#### PLANNING AND ZONING COMMISSION AGENDA-REGULAR MEETING

Monday, April 9, 2018 Ketchum City Hall 480 East Avenue North, Ketchum, ID 83340

### STAFF REPORT KETCHUM PLANNING AND ZONING COMMISSION REGULAR MEETING APRIL 9, 2018

### STAFF REPORT KETCHUM PLANNING AND ZONING COMMISSION REGULAR MEETING OF APRIL 9<sup>th</sup>, 2018

LANDSCAPE PLAN

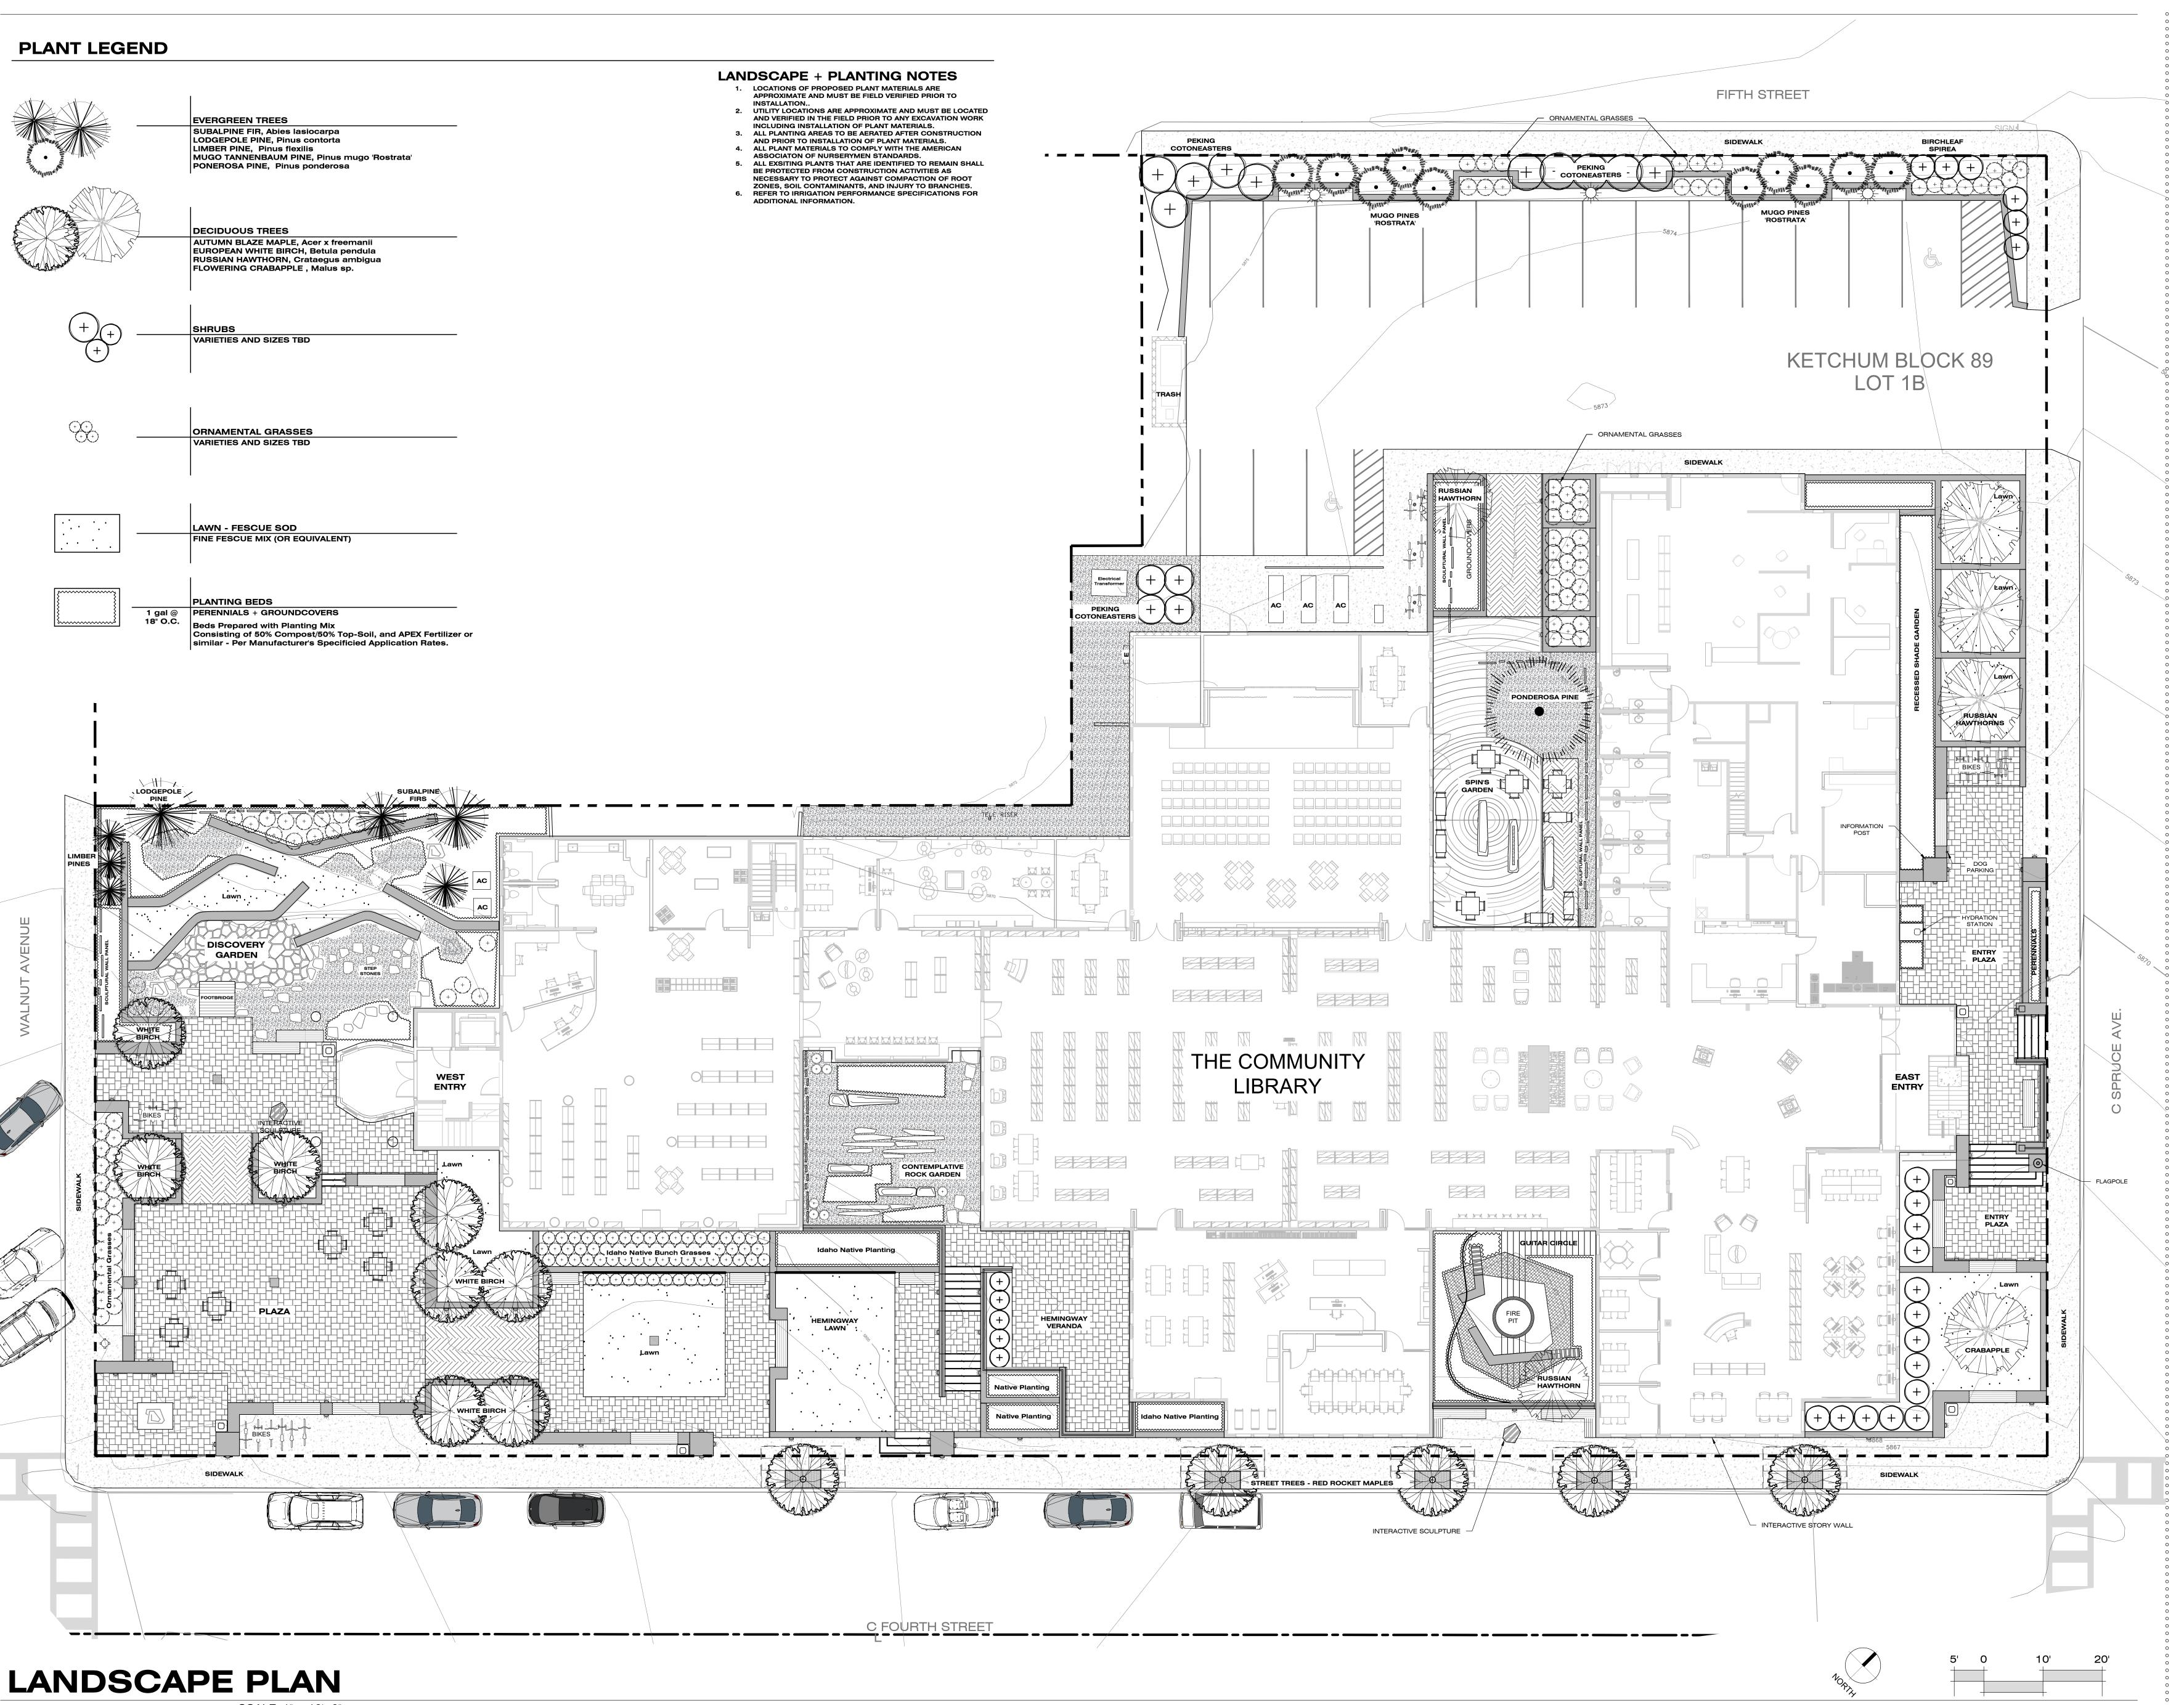
Autumn Blaze Maple, European White Birch, Russian Hawthorne, and Flowering
			Crabapples. The siting of the proposed replacement trees is indicated on Sheet L-3.0 of
			the design review submittal.
$\boxtimes$		17.96.070(D)(2)	Trees that are placed within a courtyard, plaza, or pedestrian walkway shall be
			placed within tree wells that are covered by tree grates.
		Staff Comments	The City Arborist must review and approve the proposed siting and species of the
			street trees proposed along Fourth Street as well as the decorative tree grates prior to
	 		issuance of a building permit for the project.
$\boxtimes$		17.96.070(D)(3)	The city arborist shall approve all parking lot and replacement trees.
		Staff Comments	The City Arborists has approved the proposed replacement trees. The proposed street
			trees along 4 <sup>th</sup> St shall be reviewed and approved by the City Arborist prior to issuance

SITE PLAN

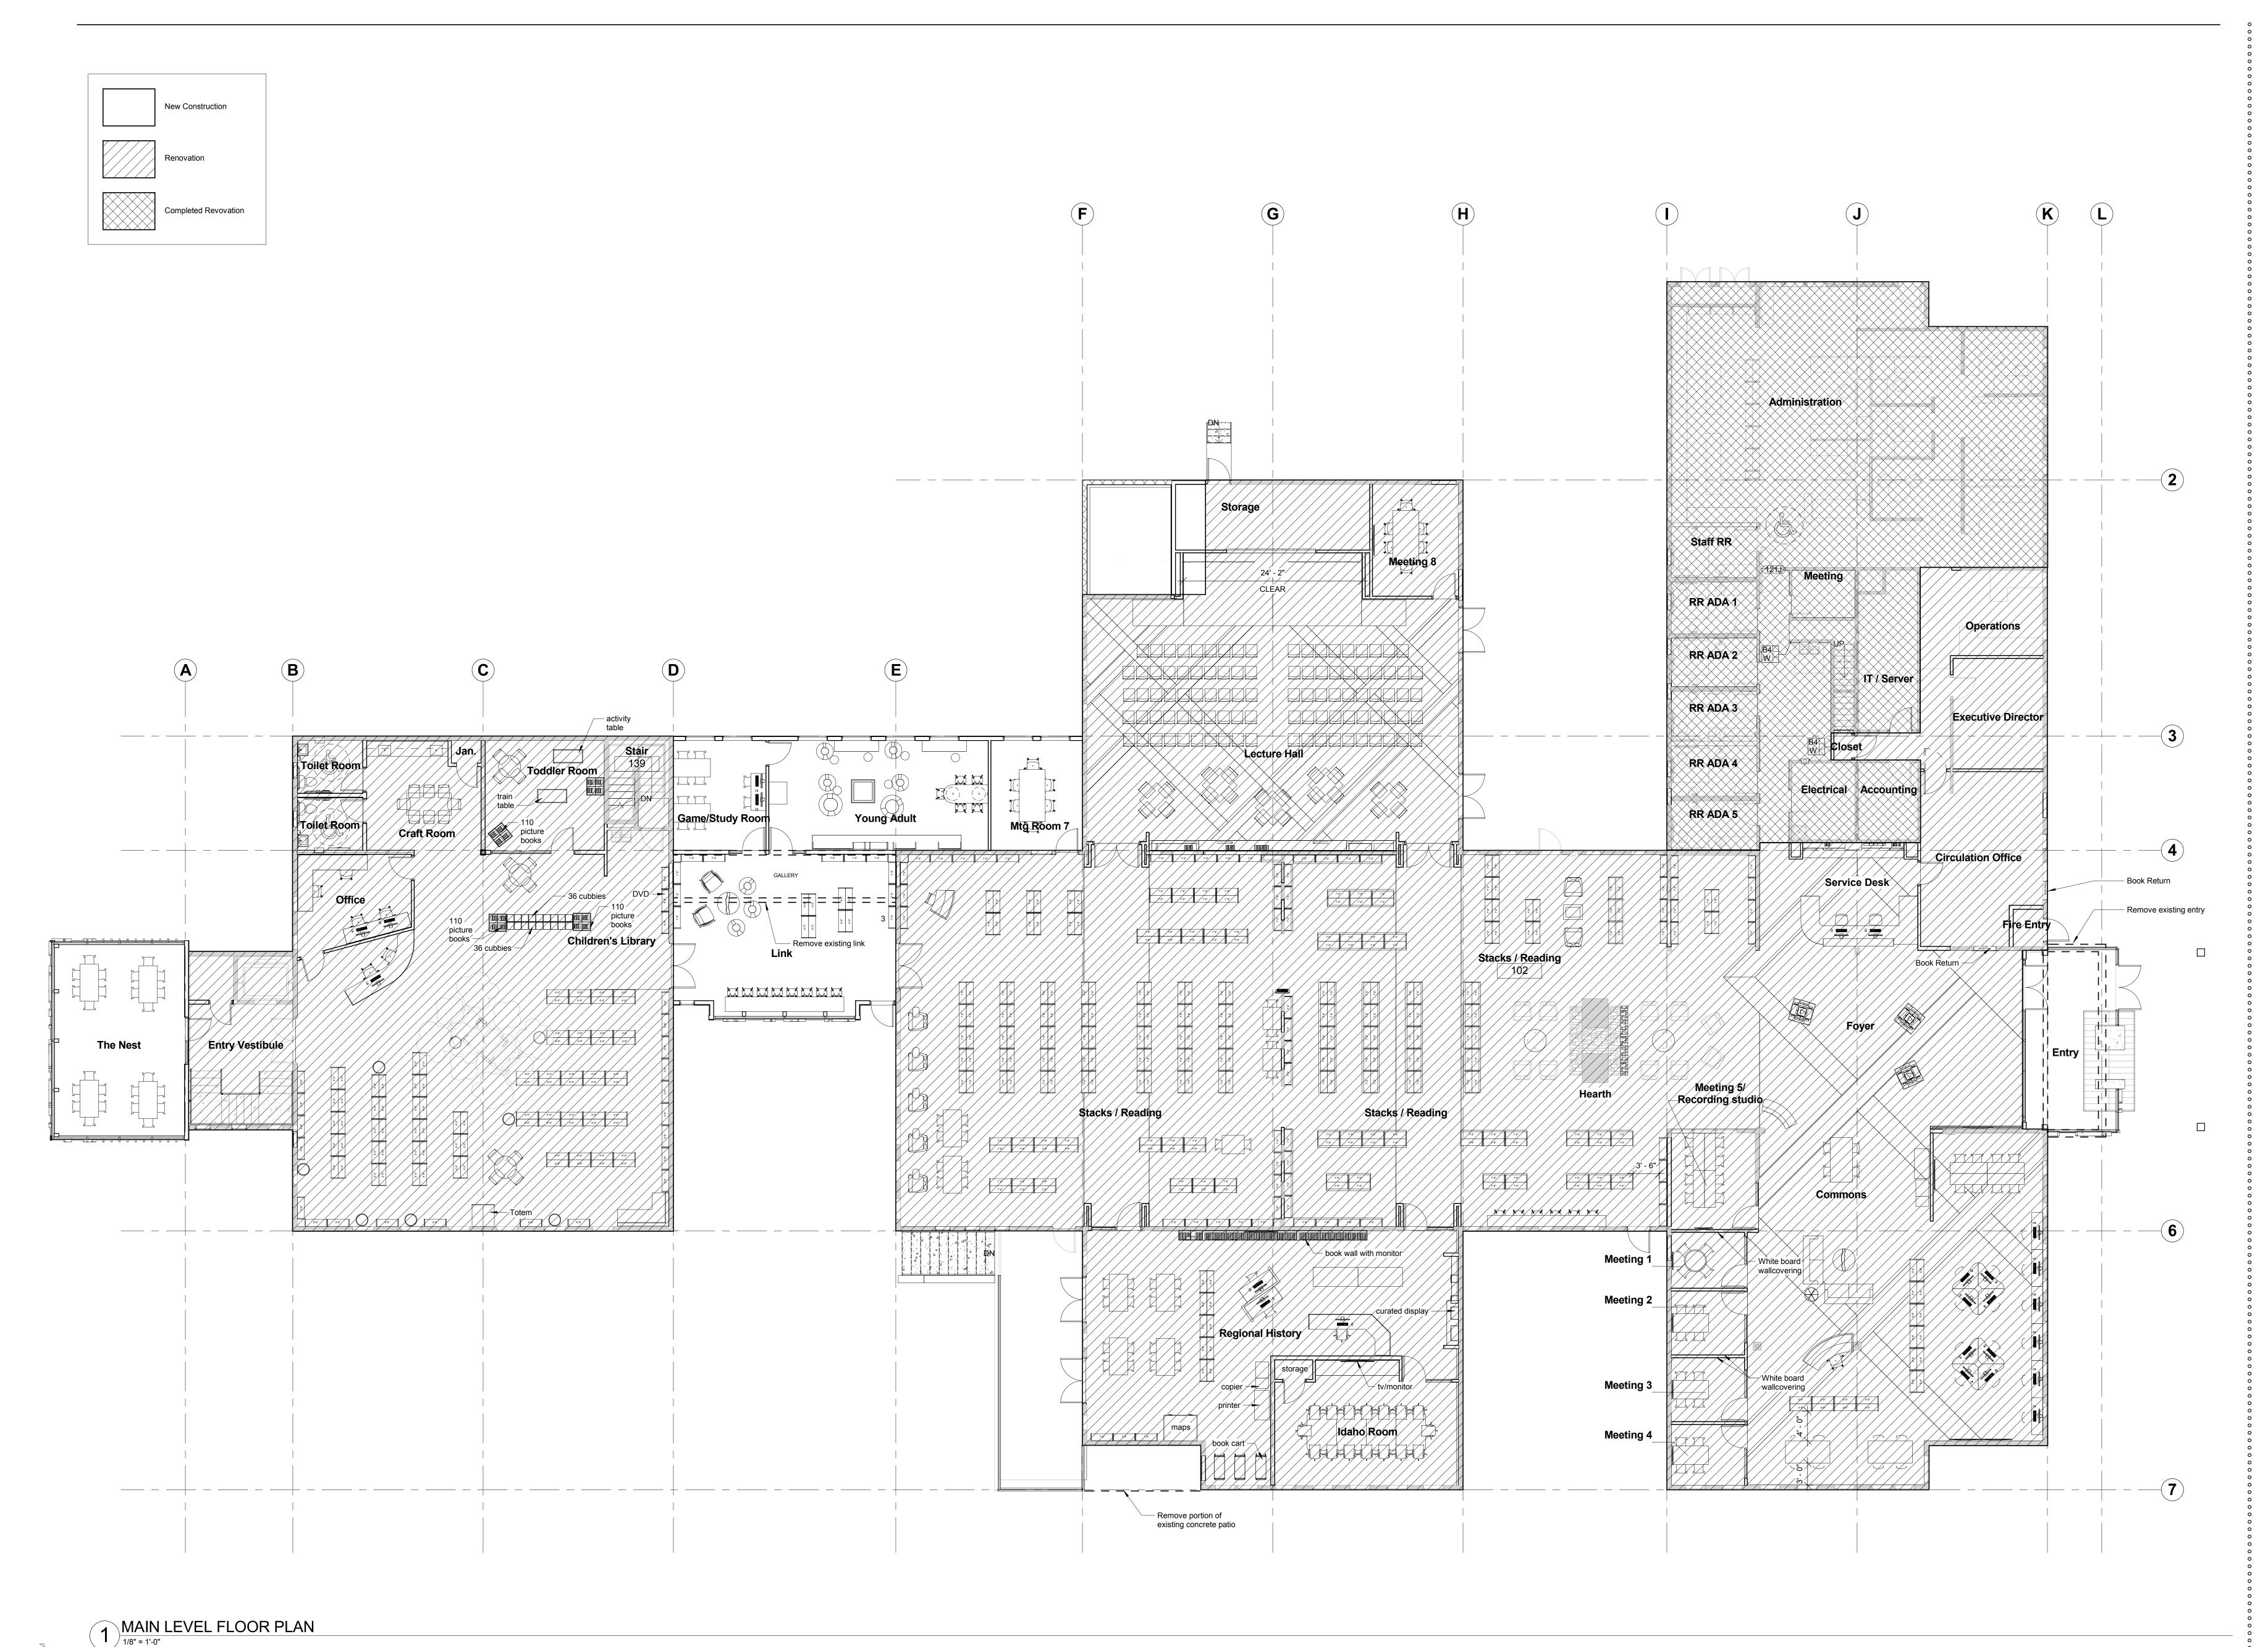
In order to approve the proposed siting and species of the street trees on 4<sup>th</sup> Street, the Planning & Building Department requires a Sidewalk Easement Agreement to ensure safe passage of pedestrian and bicycle traffic. The street trees and easement agreement must be reviewed and approved by the Public Works Department and the City Arborist.

The siting and design of the relocated fire hydrant at the corner of 4<sup>th</sup> Street and Walnut must be submitted to the Planning & Building Department to be reviewed and approved by the Fire Code Official.

The applicant has provided a revised Site Plan (Sheet L1.0) indicating the location of the proposed sidewalk easement. Staff has added two recommended conditions of approval pertaining to the proposed street trees on 4<sup>th</sup> Street: (1) the siting and species of the proposed street trees requires review and approval by the Public Works Department and City Arborist prior to issuance of a building permit for the project and (2) a sidewalk easement agreement between the City of Ketchum and the property owner must be signed and recorded prior to issuance of a Certificate of Completion for the project.

The applicant has indicated the location of the relocated fire hydrant on the revised Site Plan (Sheet L-1.1). Staff has added a recommended condition of approval that specifications for the fire hydrant at the corner of 4<sup>th</sup> Street and Walnut Avenue must be reviewed and approved by the Fire Code Official prior to issuance of a building permit for the project.
